**Re: Albert Frei & Sons, Inc.; Walstrum Quarry; File No. M-1983-033; Amendment
Application (AM-09); Third Geotechnical Review Memo**

RE: Walstrum Quarry AM-09, DRMS File No. M-1983-033
Slope Stability Review

Division’s Sensitivity Analysis

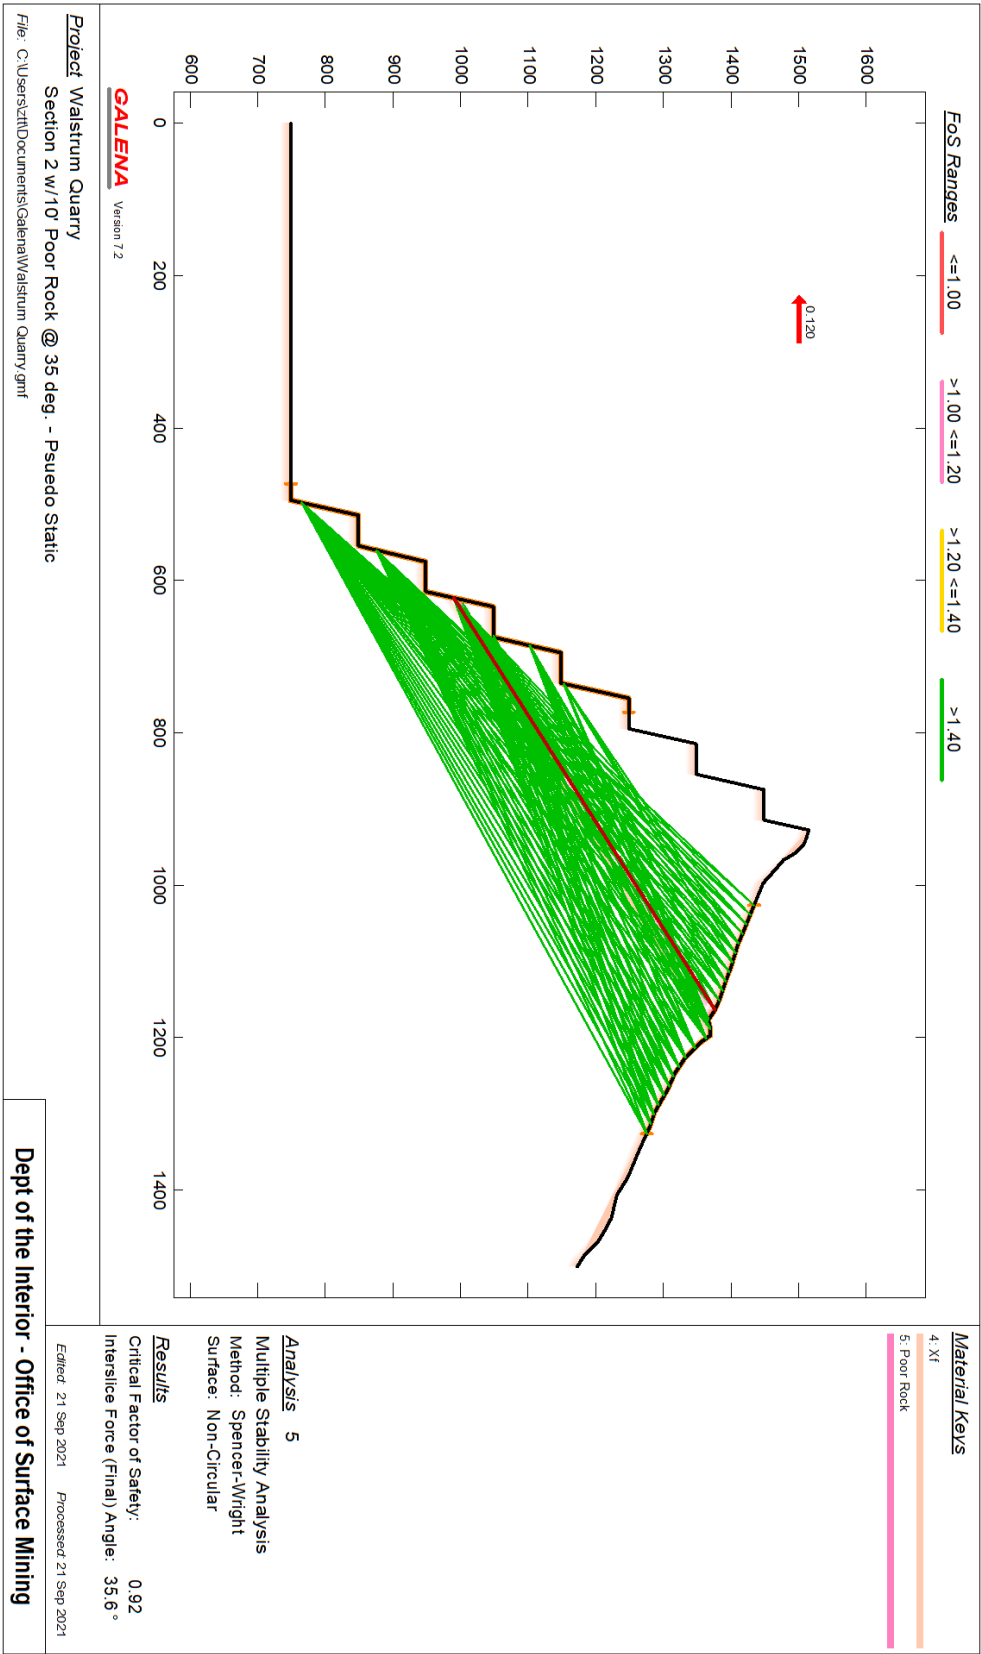
With confirmation of the slope angle error for the low strength rock (Xb) discussed in the Exhibit, the Division reconstructed the slope profile for 10-ft-thick Xb at a 35 degree angle under seismic conditions (Sensitivity Analysis) in the slope stability software, GALENA. However, the factor of safety result of the Division's slope stability analysis is still below the Division's requirement under Section 30 of the Policies of the Mined Land Reclamation Board.

As shown in the above table, the Division model for the slope profile of 10-ft-thick Xb at a 35 degree angle under static conditions resulted in a factor of safety of 1.15. The results summarized above leads the Division to believe the difference in results is either from 1) differing modeling software and methodology and/or 2) seismic conditions were potentially not included in the Walstrum sensitivity analysis. When reviewing Walstrum's resulting slope stability profile visual for the Sensitivity Analysis found in Appendix I, there is no indication a seismic coefficient of 0.12 was applied to the model outside of the associated title. At the moment, there is no way for the Division to confirm the application of a seismic condition to the Sensitivity Analysis.

- **Please have Walstrum confirm that the appropriate seismic condition was applied to the Sensitivity Analysis provided in the Exhibit.**
- **If the appropriate seismic condition was applied to the Sensitivity Analysis provided in the Exhibit, please have Walstrum provide the numerical results that outline all parameters, variables and results for the Sensitivity Analysis for the Division's review.**

Division's Sensitivity Analysis (static condition)

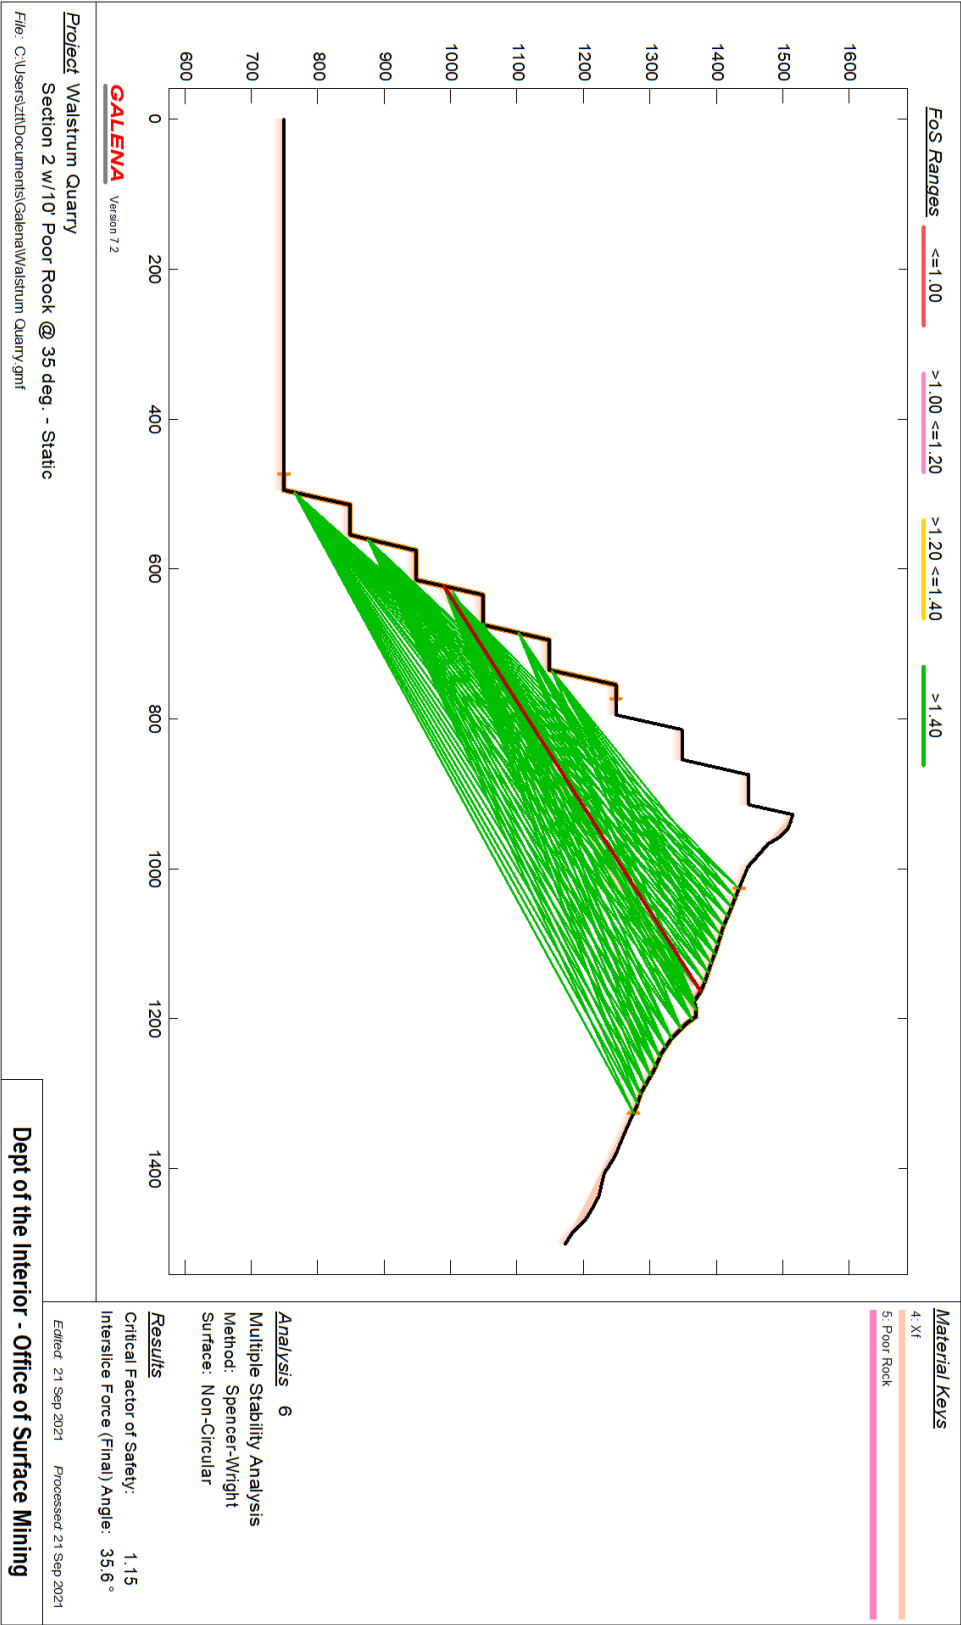
Additionally, the Division performed an additional slope stability analysis for the same slope profile but under static conditions. The resulting factors of safety is summarized below in comparison to the results provided by Walstrum and the requirements of the Division for the updated GALENA model.
